Subject: Docket Nos. 50-361 and 50-362 Response to the NRC Request for Additional Information to Support Proposed Technical Specification Number NPF-10/15-491, Reactor Coolant System (RCS) Temperature Reduction and Volumetric Minimum Flow Rate (TAC Nos. MA2238 and MA2239) San Onofre Nuclear Generating Station Units 2 and 3

The Southern California Edisons Company (SCE) Tcold Program Response to NRC Questions

### FIGURE 1

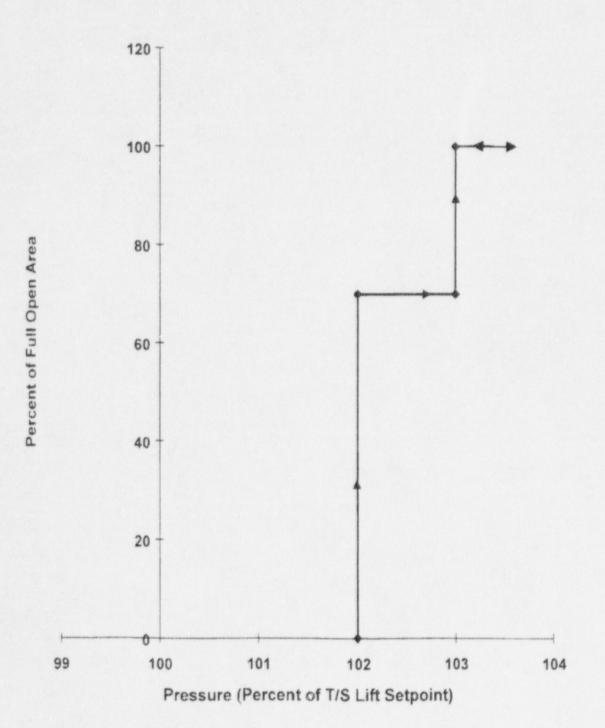
Please provide the following information regarding the high pressurizer [pressure] trip value and the main steam safety value open setpoint used in your analysis of the loss of condenser vacuum event with concurrent single failure. Discuss instrument uncertainties, tolerance, and/or accumulation as applicable. For the main steam safety values, the technical specification (TS) lift setpoints vary from 1085 psig to 1140 psig. Discuss how this was modeled in your analysis.

Nine main steam safety valves (MSSVs) are included on each of the two main steam lines. The lift setting (in psig) for each MSSV is listed in TS Table 3.7.1-2. The listed values are 1085, 1092, 1099, 1106, 1113, 1120, 1127, 1134, and 1140 psig. The LOCV+SF analysis increases the TS lift settings to account for +2 % opening tolerance and MSSV opening characteristics as follows:

- Step 1. Since the CESEC code pressure lift setting is in psia, rather than psig, 15 psi is added to the TS value to convert the lift setting to psia. The value of the lift setting in psia is multiplied by 1.02 to adjust for +2 % opening tolerance. The resulting adjusted MSSV opening setpoints are 1122, 1129.1, 1136.3, 1143.4, 1150.6, 1157.7, 1164.8, 1172.0, and 1178.1 psia.
- Step 2. The MSSV characteristics are modeled as indicated in Figure 1. The abscissa of Figure 1 is in units of percent of the TS lift setting in psia. From Figure 1 it is seen that each MSSV is assumed to open to 70% of Full Open area at the adjusted MSSV opening setpoint listed in Step 1 above. After an accumulation of 1 %, each MSSV is assumed to open to 100 % of the Full Open area.

In the LOCV+SF analysis, seven of the nine MSSVs in each steam line reached their opening setpoints and five of these seven reached a full open condition.
